# Staff Report PC23-057-PP

## Windswept Farms Primary Plat

### Docket PC23-057-PP – Primary Plat – Windswept Farms

PRIMARY PLAT - KEY MAP

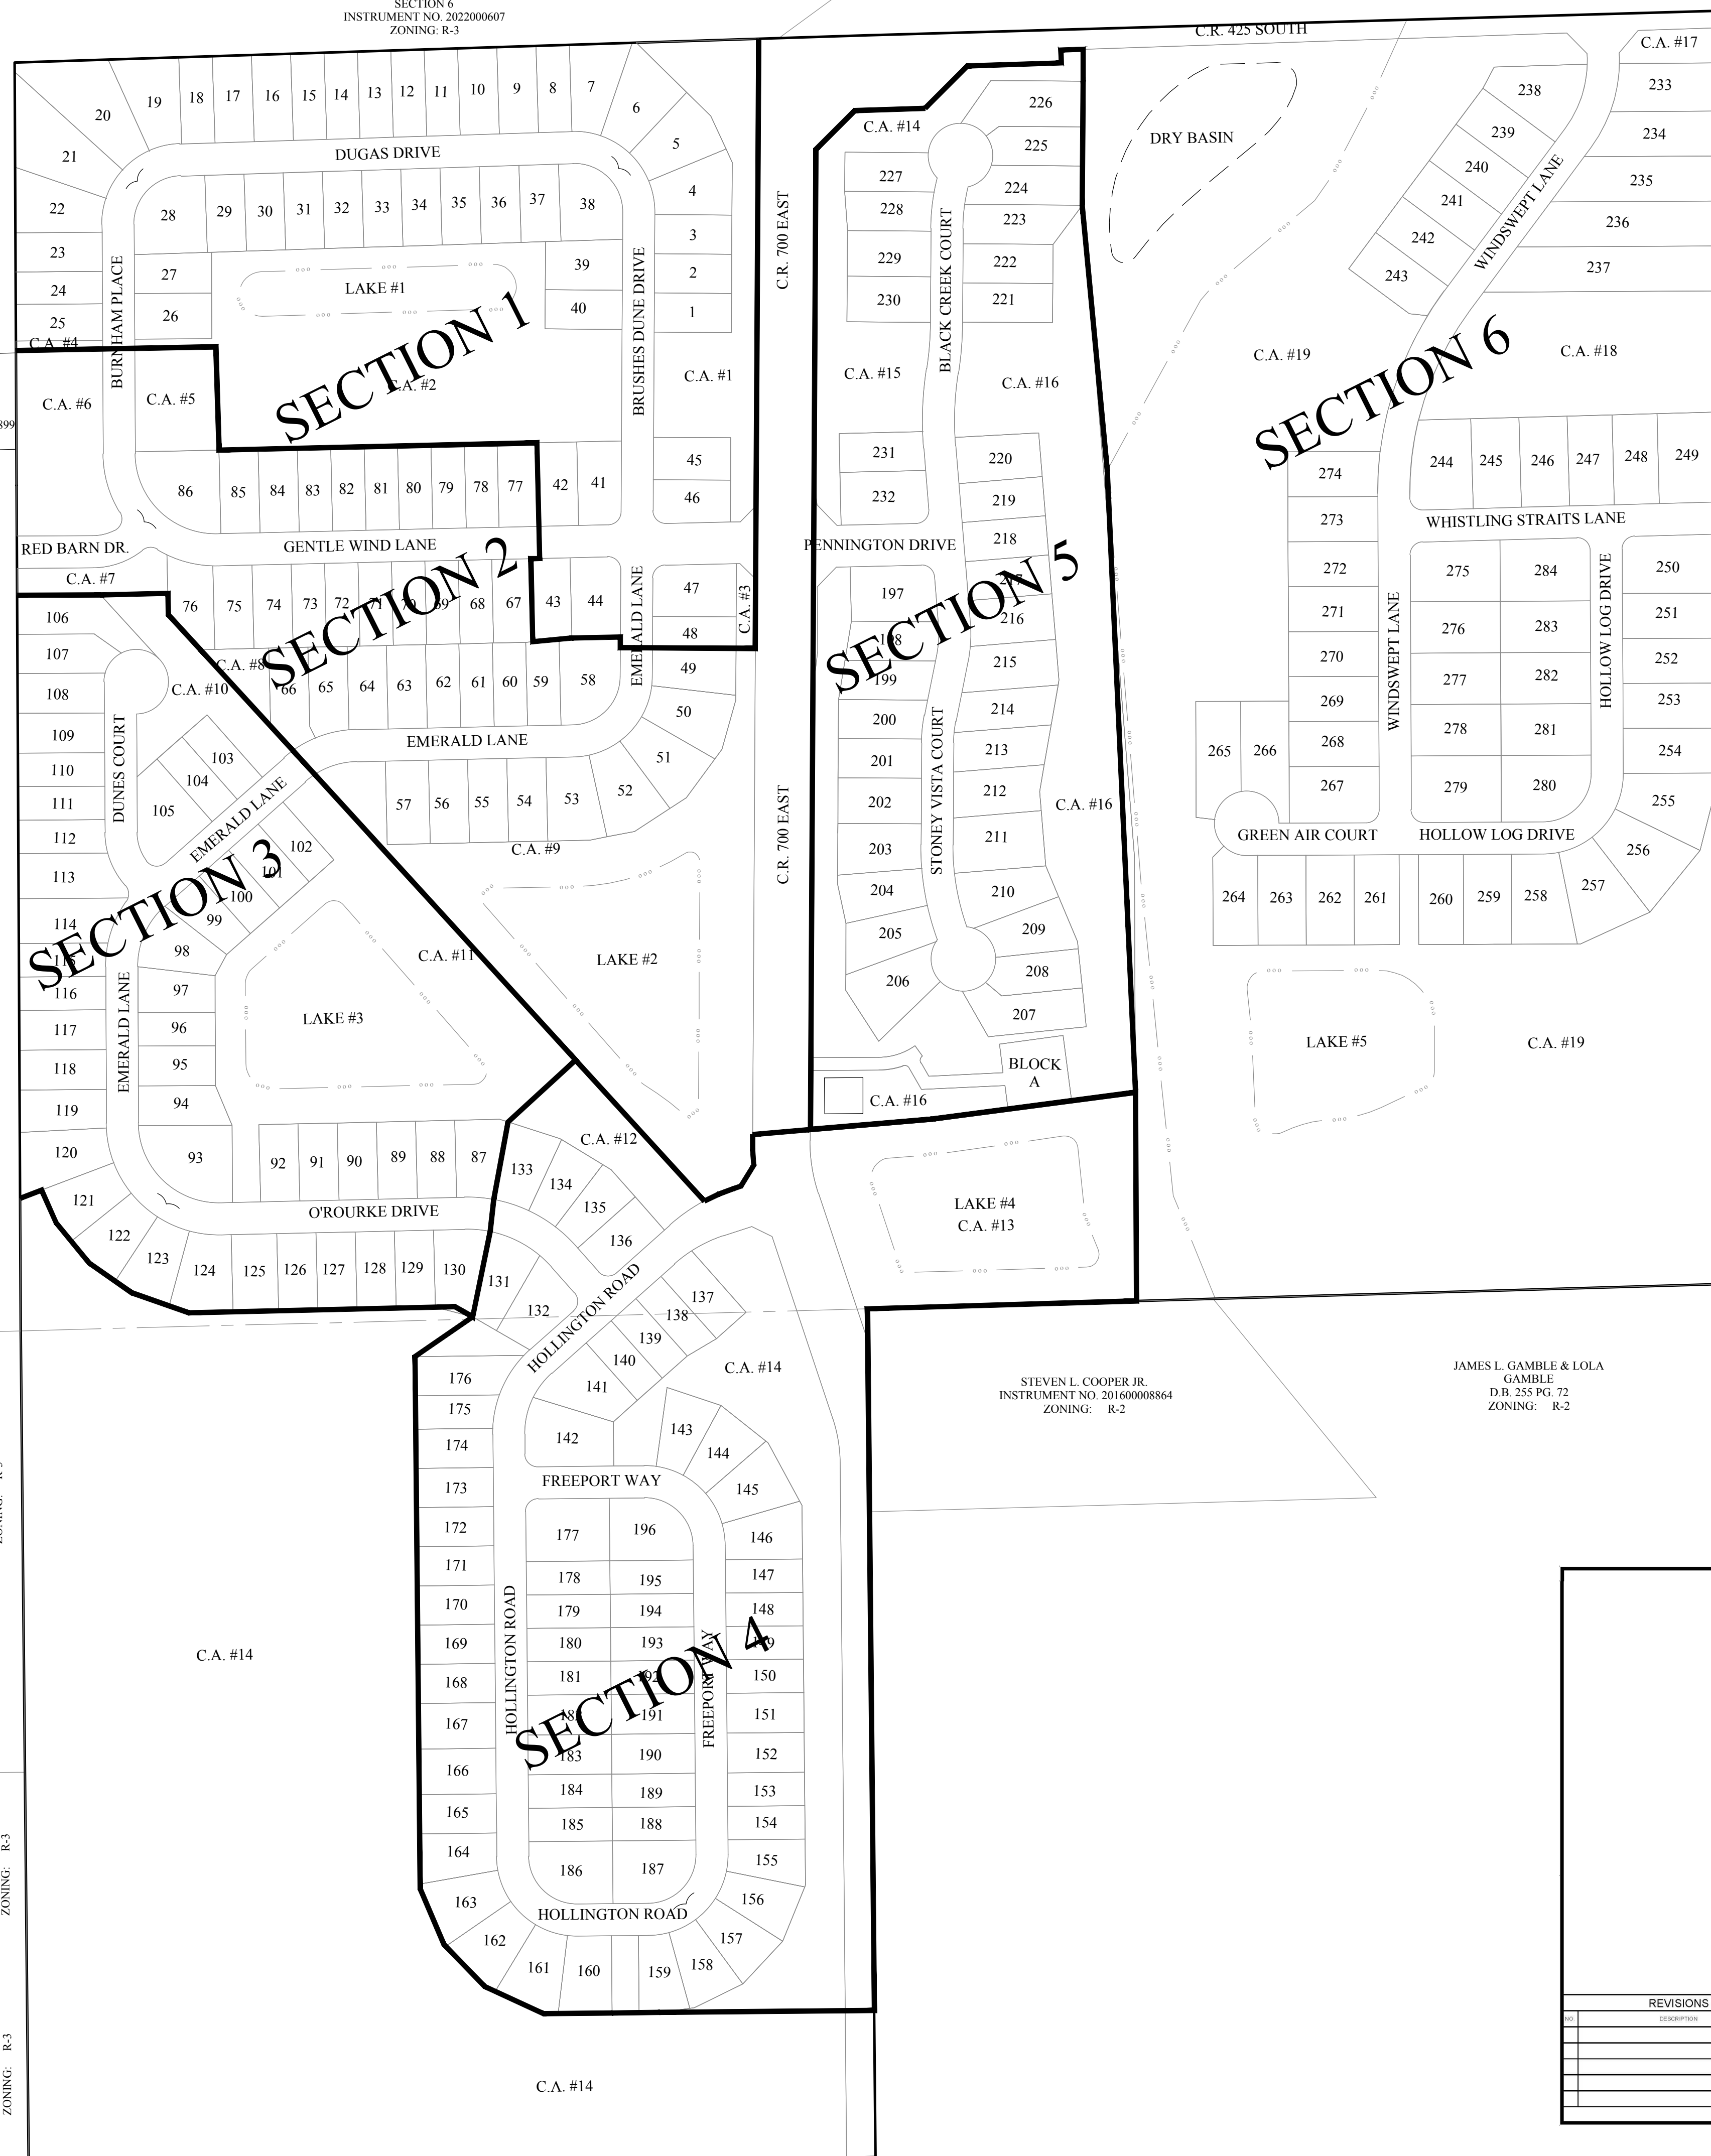
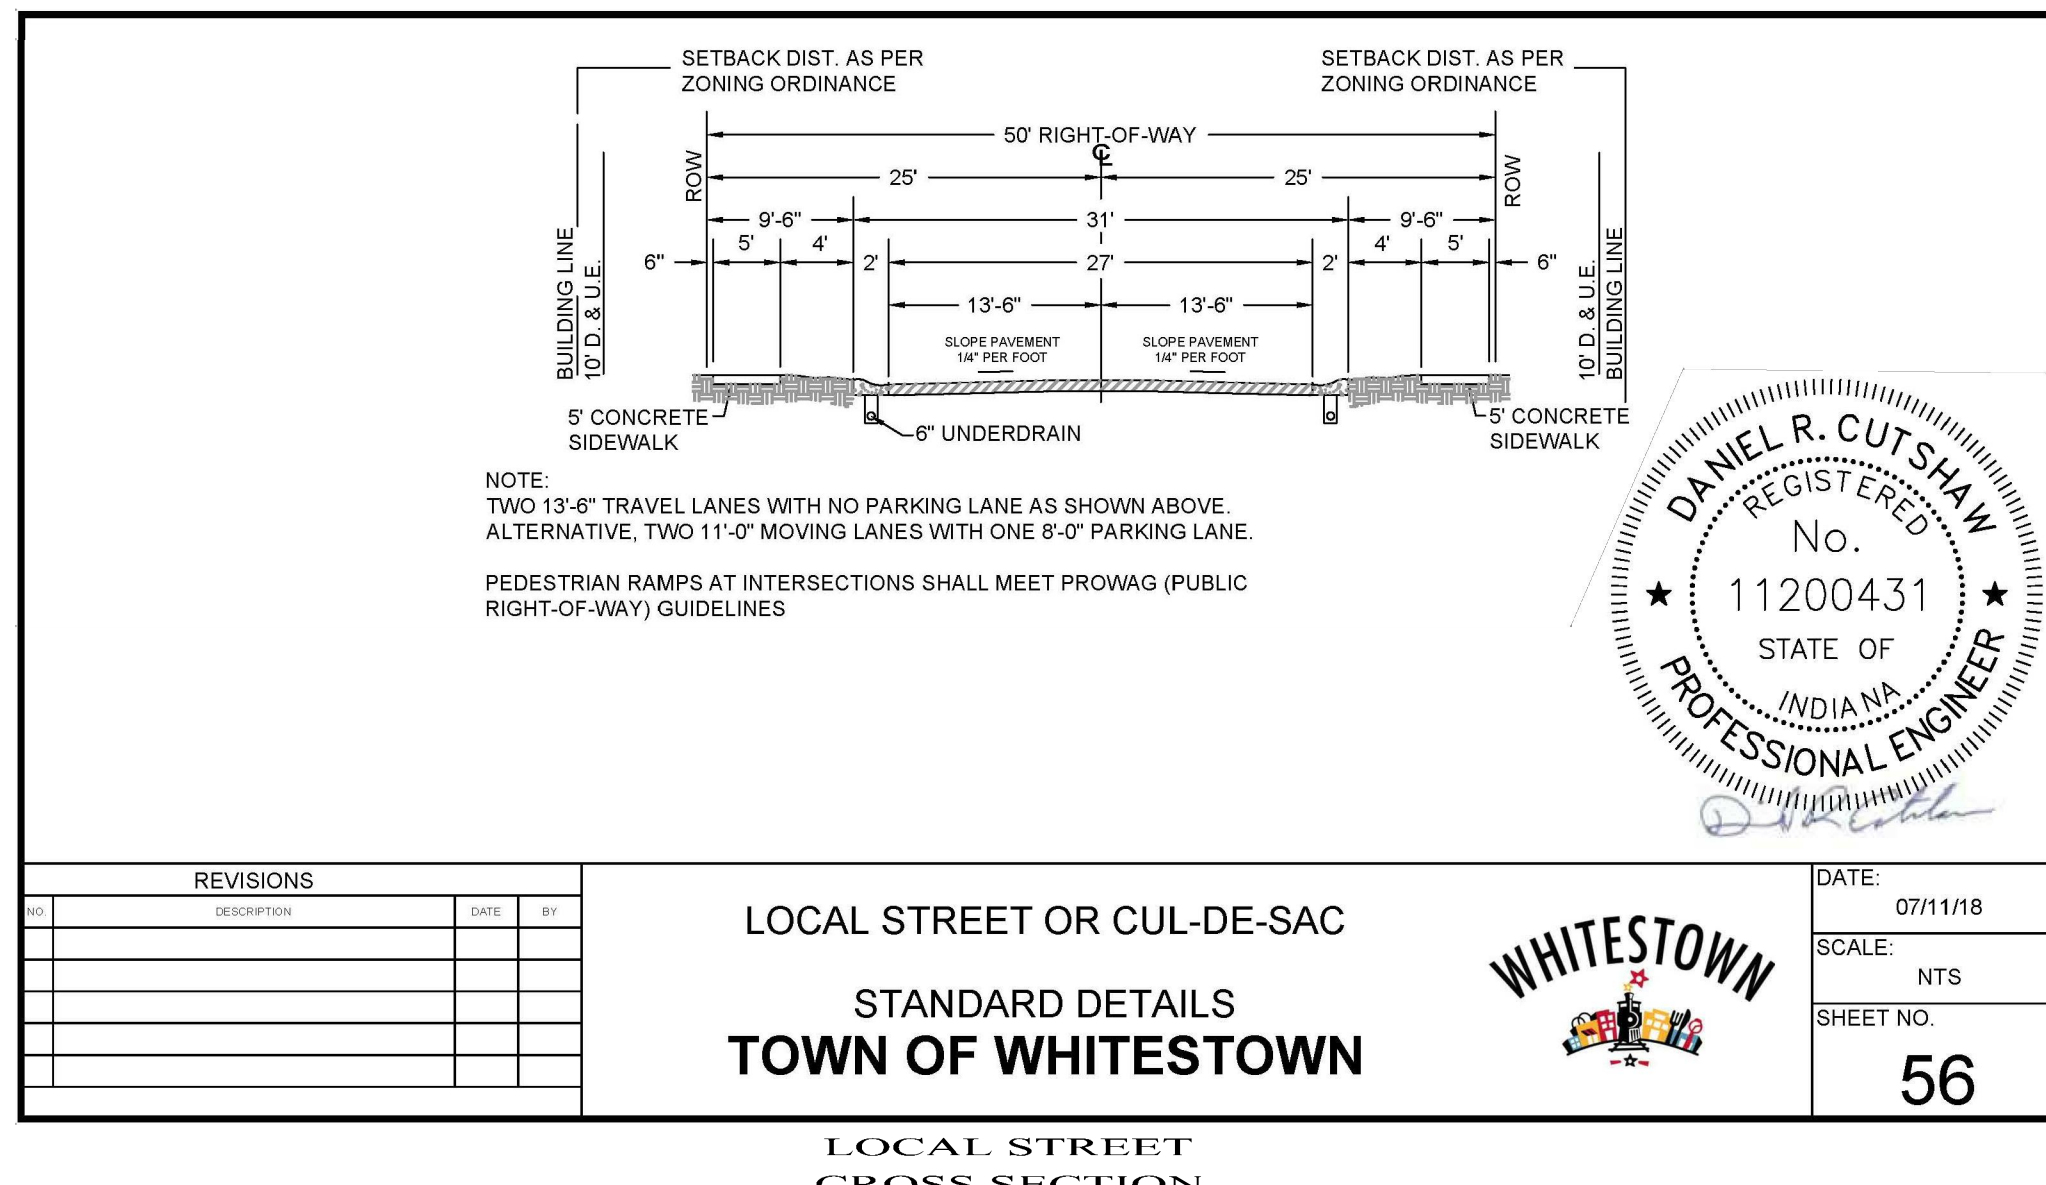
**Petitioner Request:** To exceed the maximum length by 64 feet from 600’ to 664’

**Petitioner Request:** To accept the historic barn and 50 acres of tree preservation areas as meeting the neighborhood park requirements.

**Petitioner Substitution:** To substitute the Historic Barn, trail system, and 50 acres of preservation areas as the Amenity Center Requirement of UDO Article 9.11 (H)(2).

**Staff Recommendation:** Staff is providing a favorable recommendation of the cul-de-sac waiver to exceed the maximum length of the cul-de-sac. There is a 16’ emergency access drive connected to the cul-de-sac instead of a public road that would meet the 600’ requirement. The site is geographically constrained with floodplain/floodway and utility easements that limit the site from being designed in an alternative matter. When making any recommendations staff looks at the following criteria:

**Staff Recommendation:** Staff would not be in support of the waiver as suggested because staff believes the petitioner can meet the Neighborhood Park Standard outlined in the UDO. Staff would support this waiver if the petitioner were to change the request to modify the tree requirement (1b) and trail surface (1d) requirements to count the woods and allow asphalt as a trail surface respectively. By making these adjustments, Staff believes the petitioner can align with the intent of the minimum standards for a passive neighborhood park (Article 9.11 (I)(1)).

**Staff Recommendation:** It is staff's position that the petitioner's substitution request falls short of the equivalent or greater standard mandated by strict compliance with the UDO. Other subdivisions have included the trail system and met the Amenity Center Requirement, Staff recommends denying the proposed alternative substitution.

1. Provide a Rapid Flashing Signal at the trail intersection of C.R. 700 East.
2. Trail Connection resembling the example shown in Article 9.4(D), connecting the 5' sidewalk to the 8' path on the east side of CR 700 E.
